SUBJECT: Technical Specifications Proposed Change No. 293
Revised Reactor Vessel Pressure-Temperature Limitation Curves
Vermont Yankee Nuclear Power Station
Docket No. 50-271
License No. DPR-28

Proposed Change 293

Description and Evaluation of Proposed Changes

Figure 3.6.1

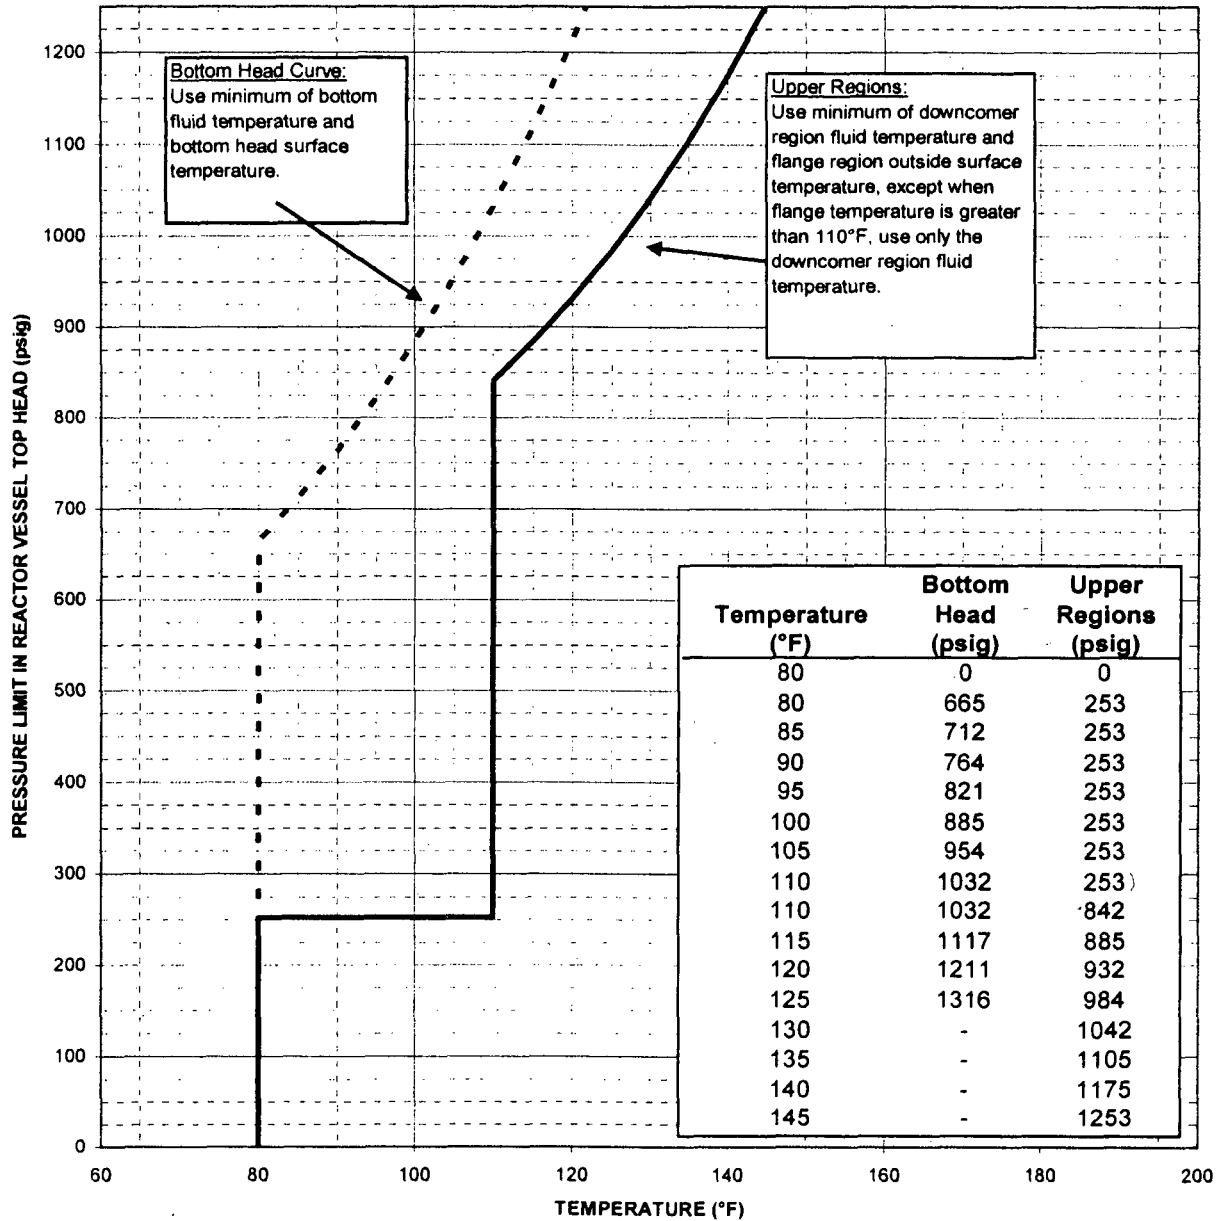
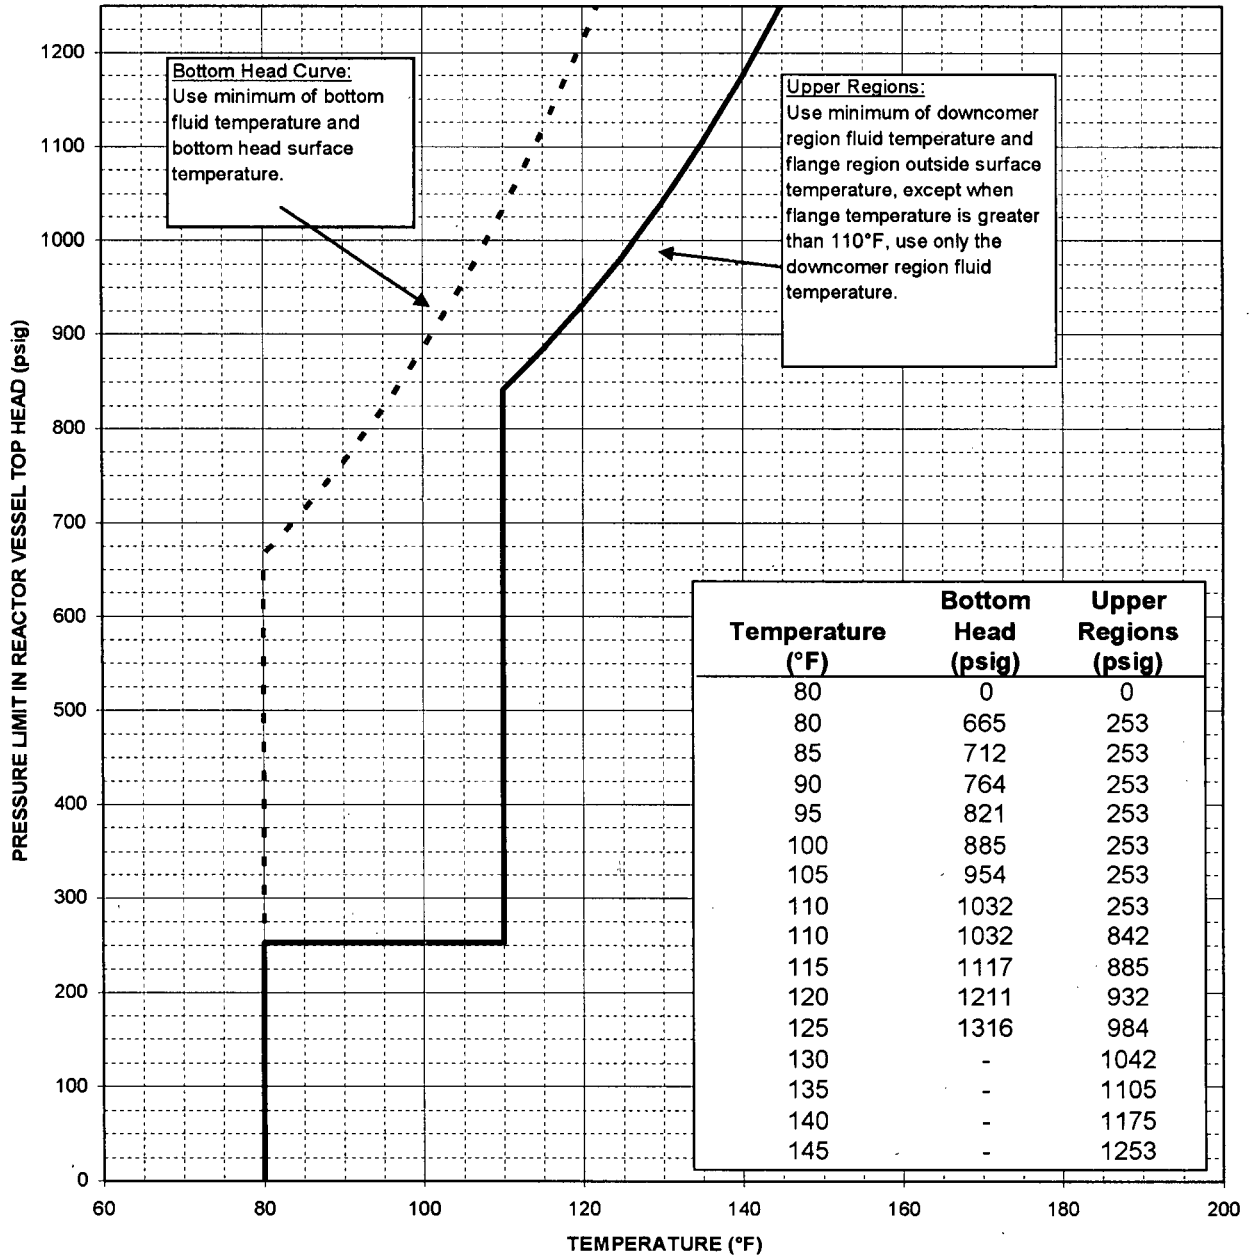
VY is proposing to update the pressure and temperature (P-T) limit curves for the reactor coolant system that are required by TS 3.6.A, "Pressure and Temperature Limitations." Currently, TS Figures 3.6.1, 3.6.2 and 3.6.3 indicate validity through 4.827×10^8 megawatt-hours thermal (MWH(t)), approximately at the end of the current operating license. This proposed change updates the pressure and temperature limits for the reactor coolant system through 7.943×10^8 MWH(t), approximately the end of the prospective twenty (20) year renewed license period, depending on the plant capacity factor. The updated P-T limits are based on technical requirements and analyses that have been previously reviewed and approved by the NRC for VY (as will be explained in detail below), thus this Technical Specification change can be considered an administrative update. The set of P-T limit curves is unchanged and remains as shown in current TS Figures 3.6.1, 3.6.2 and 3.6.3.

40°F/hr Heatup/Cooldown Limit
Valid Through ~~4.827E8~~ MWH(t)

40°F/hr Heatup/Cooldown Limit
Valid Through 7.943'E8 MWH(t)

Figure 3.6.3

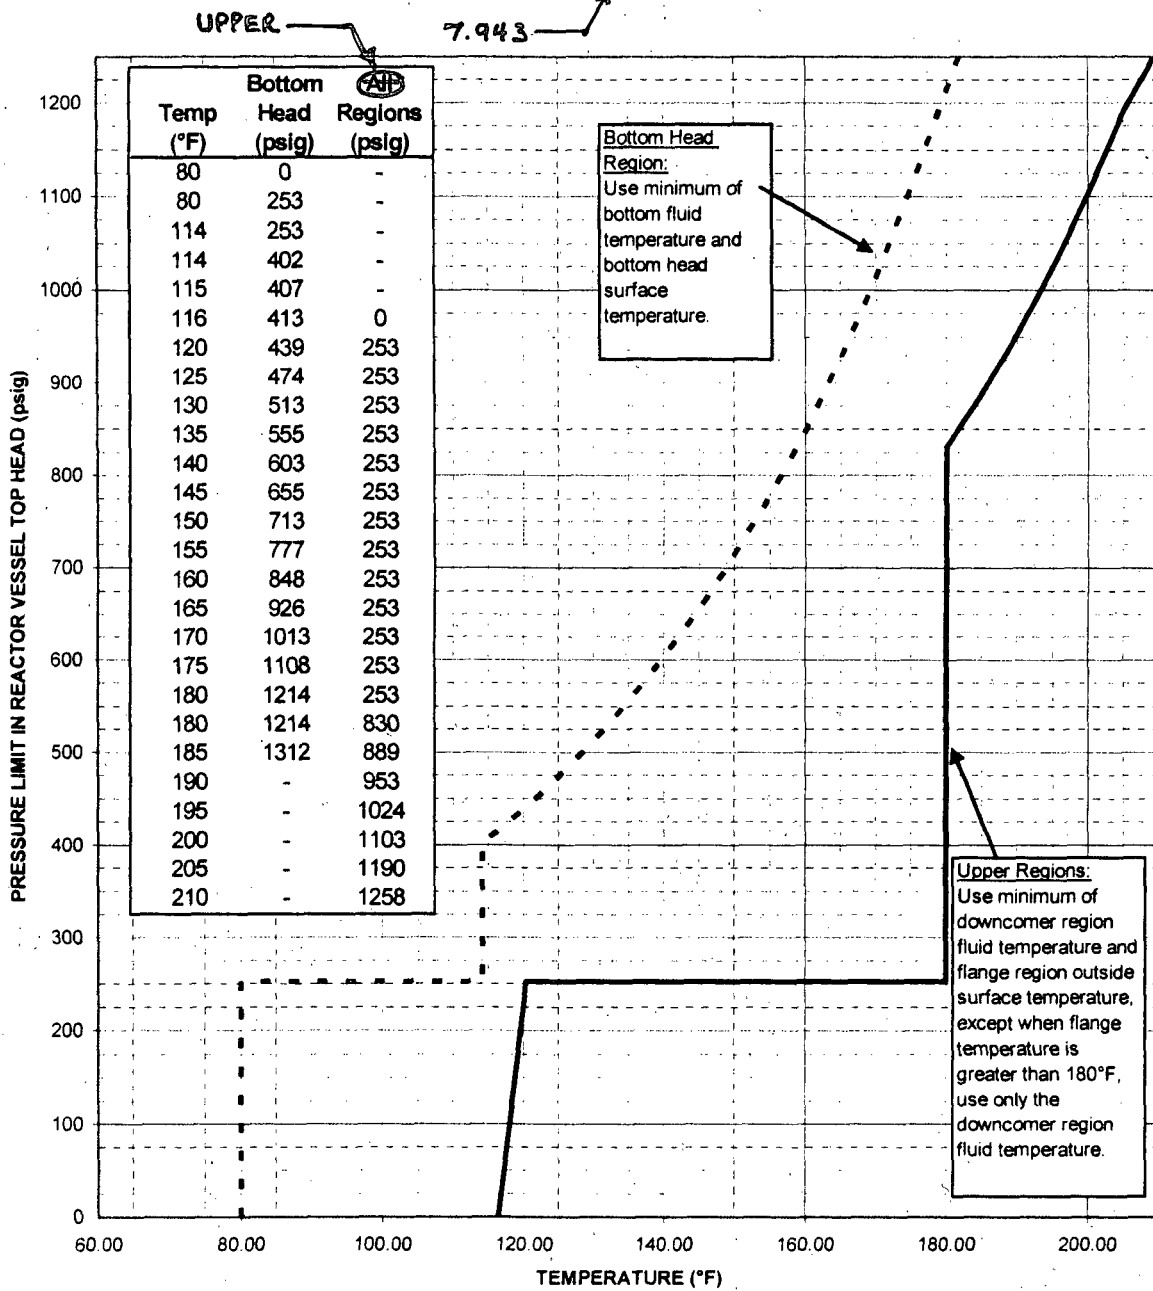
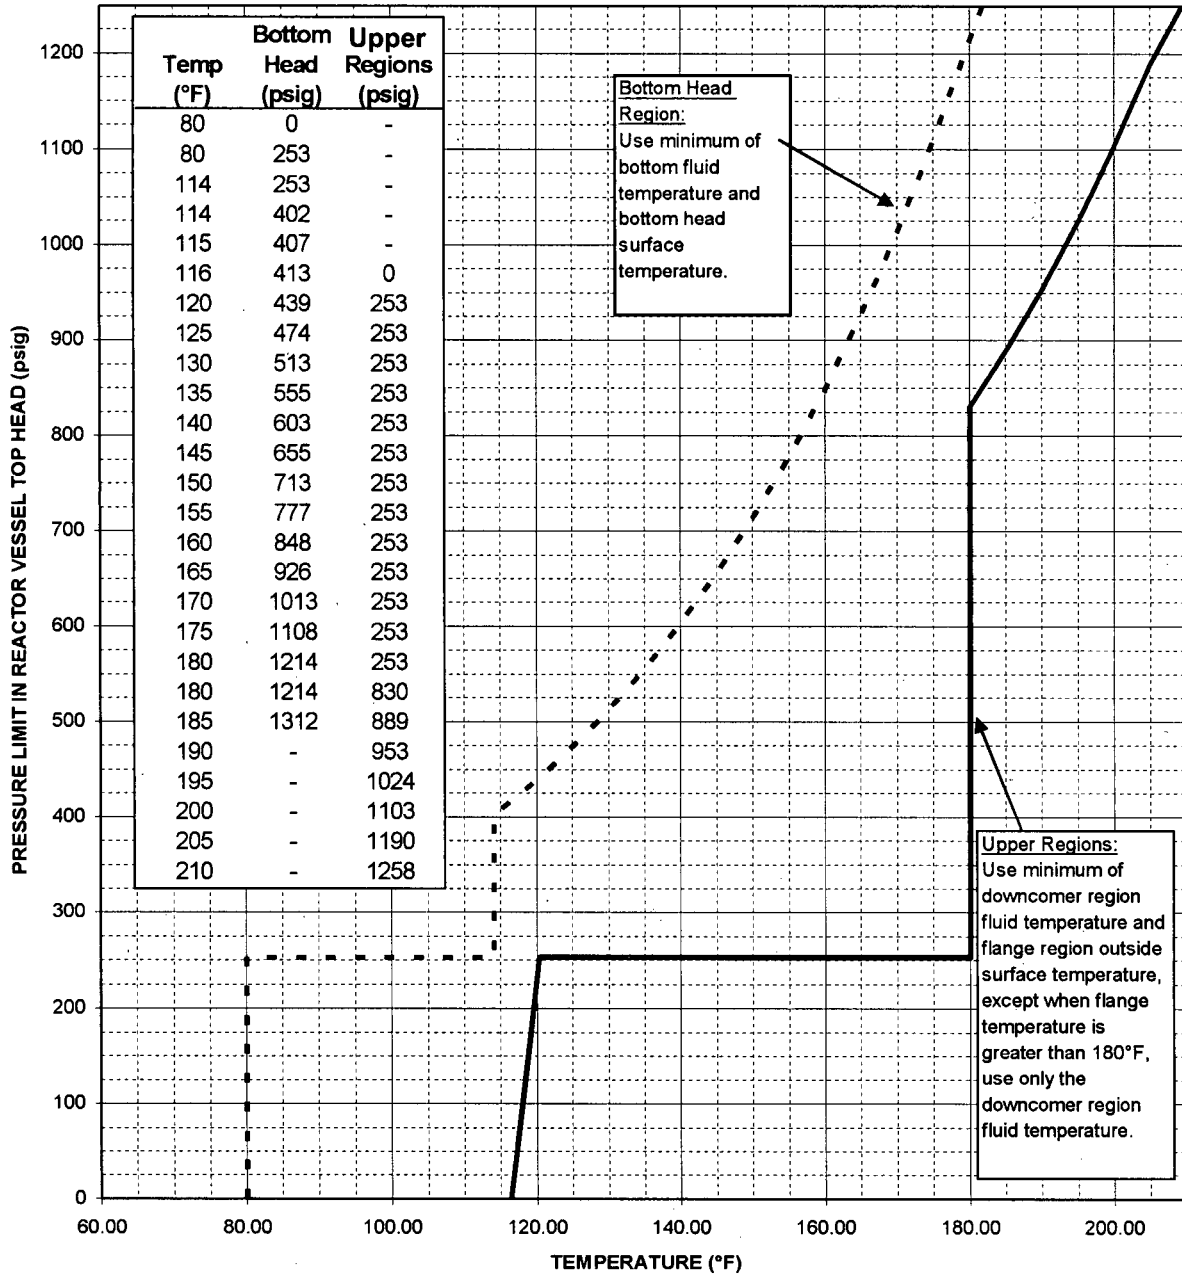
In addition, an editorial correction is being proposed in Table 3.6.3. The data box on Figure 3.6.3 has a heading titled "All Regions" and this should be labeled "Upper Regions" as it is similarly labeled elsewhere on the figure and on Figures 3.6.1 and 3.6.2.

In addition, an editorial correction is being proposed in Table 3.6.3. The data box on Figure 3.6.3 has a heading titled "All Regions" and this should be labeled "Upper Regions" as it is similarly labeled elsewhere on Figure 3.6.3 and also on Figures 3.6.1 and 3.6.2.

If Pressure < 253 psig, Water Level must be within
Normal Range for Power Operation
Valid Through 4.827E8 MWH(t)

**100°F/hr Heatup/Cooldown Limit
If Pressure < 253 psig, Water Level must be within
Normal Range for Power Operation
Valid Through 7.943 E8 MWH(t)**
